# Groundwater Transfer Review Summary Form

Transfer/PA # T- 14686 (RA)

Application: T-14686

Applicant Name: City of Hubbard

Well Location Map

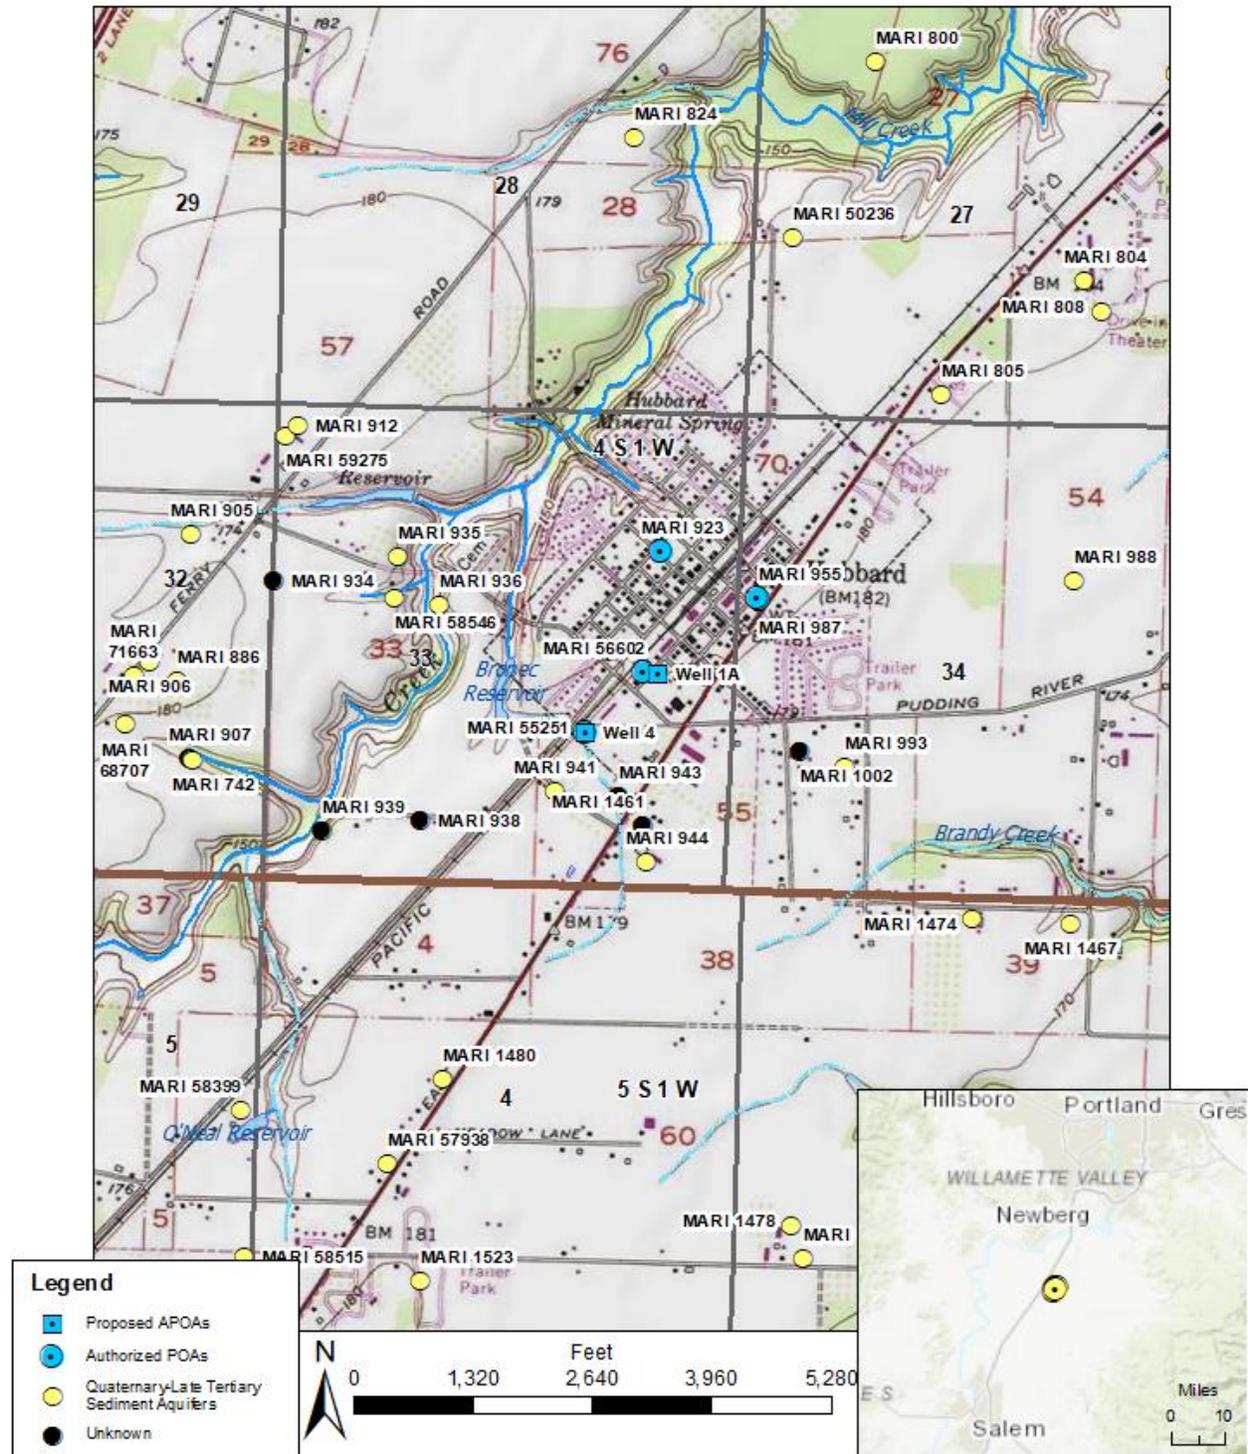
5. a) Will this proposed change, at its maximum allowed rate of use, likely result in an increase in interference with **another ground water right**?  
 Yes  No Comments: MARI 55251 is closer to MARI 941 than the authorized POAs under Certificate 84092. MARI 941 is a POA under Certificate 38364 which authorizes irrigation of 8.3 acres at a maximum rate of 0.10 cfs. The well log for MARI 941 reports a well depth of 255 feet and a static water level of 35 feet on March 22, 1967. MARI 55251 is located approximately 812 feet northeast of MARI 941, whereas MARI 56602 is approximately 1700 feet northeast from MARI 941. The reduced intervening distance will likely result in an increase in interference with this groundwater right.

- b) If yes, would this proposed change, at its maximum allowed rate of use, likely result in another groundwater right not receiving the water to which it is legally entitled?  
 Yes  No If yes, explain: To assess potential injury at MARI 941 due to the proposed use, drawdown resulting from pumping at MARI 55251 was estimated using the Theis (1935) solution for drawdown in a confined aquifer (see attached Theis Drawdown Analysis). MARI 55251 is an authorized POA for municipal use on Certificate 90750 (0.668 cfs) and Permit G16138 (0.223 cfs). To be conservative, the total combined maximum rate under all authorized and proposed use at MARI 55251 (2.451 cfs) was used for the Thies analysis. Results of the Theis analysis indicate that pumping at the maximum allowed rate of use at MARI 55251 would likely result in less than 50 feet of drawdown at MARI 941. The reported well yield for MARI 941 is less than half of the maximum allowed rate of use so the actual interference at MARI 941 is expected to be much less than 50 feet. The proposed use is not expected to result in substantial or undue interference with MARI 941 or other nearby groundwater rights.

6. a) Will this proposed change, at its maximum allowed rate of use, likely result in an increase in interference with **another surface water source**?  
 Yes  No Comments: MARI 55251 would be closer to Mill Creek and an unnamed tributary to Mill Creek than the authorized POA locations. The reduced intervening distance could result in an increase in interference with these surface water sources.

Provide context for minimal/significant impact: The proposed change is unlikely to cause a significant increase in interference with nearby surface water sources because nearby streams do not fully penetrate the Willamette silt unit so the connection between surface water and the underlying aquifer is inefficient. Approximately 80 feet of fine-grained sediments underlying the streams will diffuse impacts over a larger area and longer period.
